PROJECT PROJECT REF.	77-79 MOSLEY ST 1995	DATE	JULY 2024
---------------------------------	-------------------------	-------------	-----------

App refs: 139183/FO/2024, 139184/LO/2024

This report is written in response to comments received from the Planning dept. on 18th July 2024.

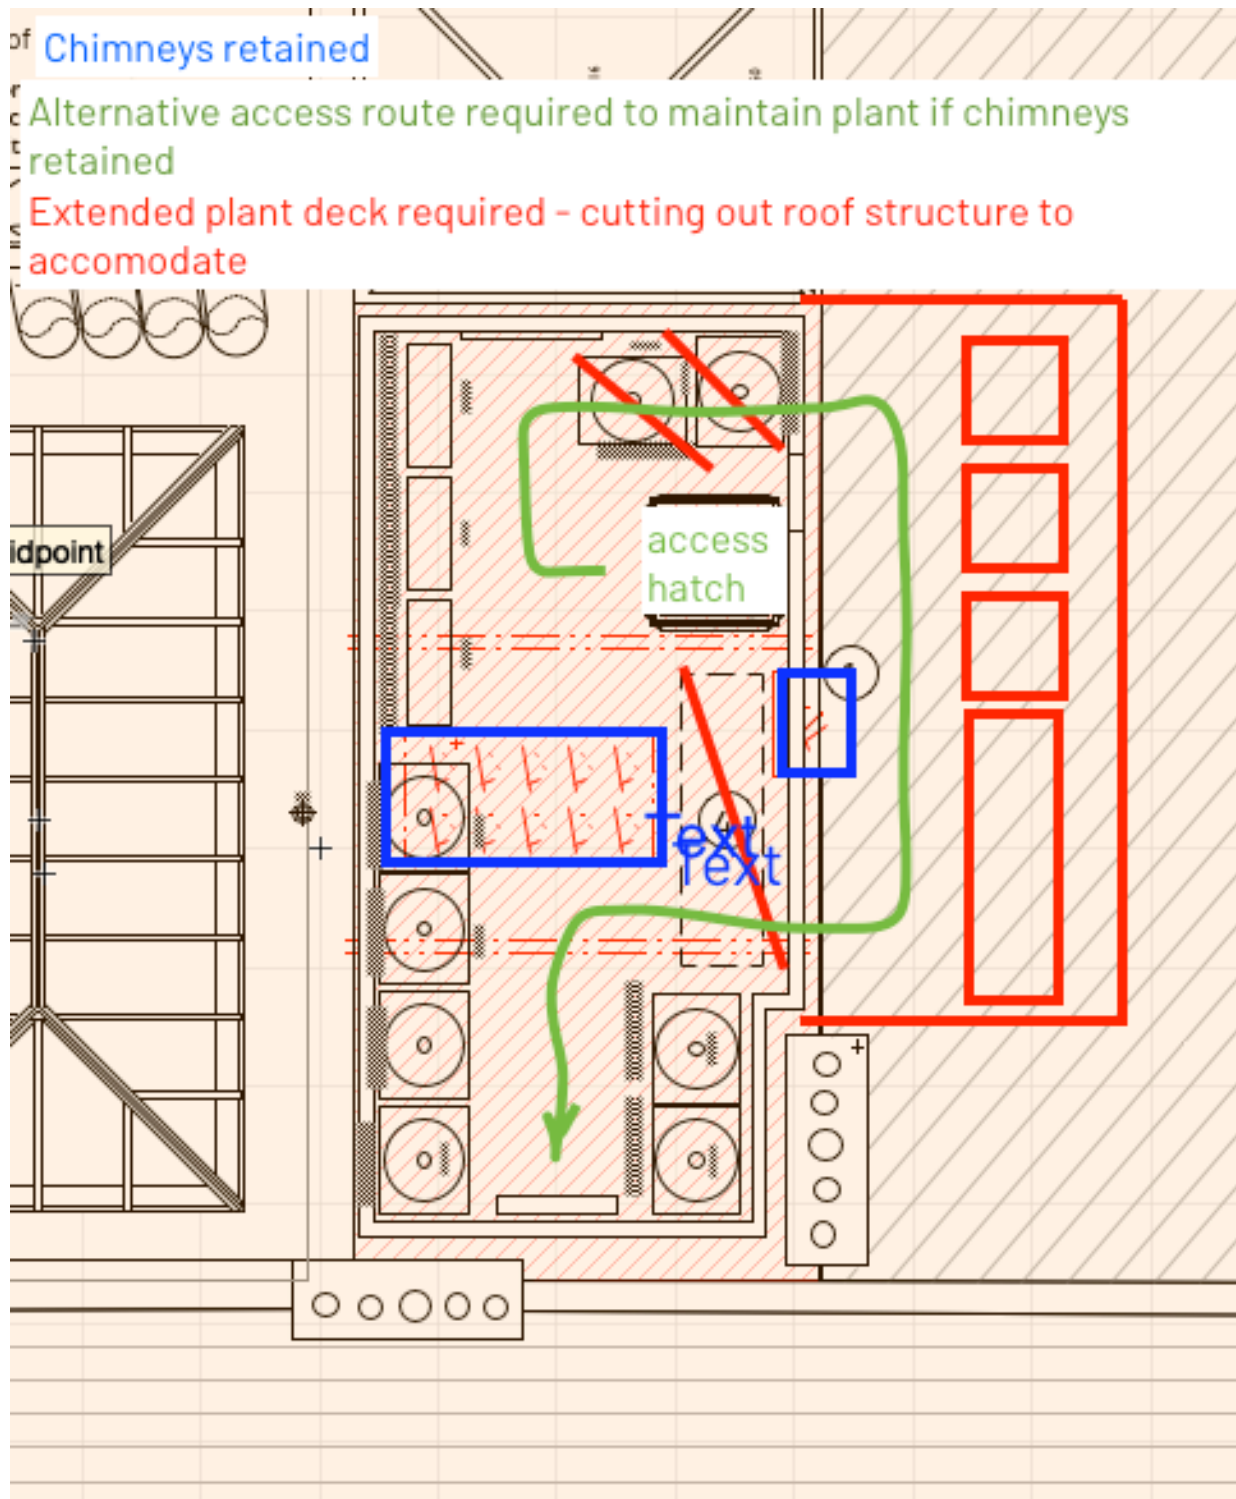
Ref 31. The plant deck seems to be in the original position following an options appraisals seems to be the only suitable location - if this section of roof is being removed then it would be good to know what the existing roof structure is and whether it has a timber truss construction or whether it is purlin and rafter construction . If it is the former then can the trusses be retained in situ and encapsulated with the plant working around these features. We should also aim to retain the main chimney stack as the chimney breast in now being retained below . We asked the question whether a section of the roof could be retained so as to retain its form, could a section therefore be cut out of the roof to the minimum necessary to provide the plant needed rather than the whole roof. The roof will need recording before any alterations and we will need a method statement for the alterations and detailed design and waterproofing works.

We have updated drawing P(300) to note that the truss chord can be retained. However, as per new drawing P(380), the location of the existing trusses is such that they cannot be retained. It would not be possible to locate and manoeuvre around the plant equipment within the size of deck. You will note that in our latest proposals, we have managed to rearrange the plant deck such that one of that 2no. existing chimney stacks can be retained. Unfortunately, the remaining stacks sit centrally to the plant deck. As a result, if these were to be retained, we would need to significantly enlarge the plant deck to create a route around the equipment. See rough mark-up here to illustrate this point.
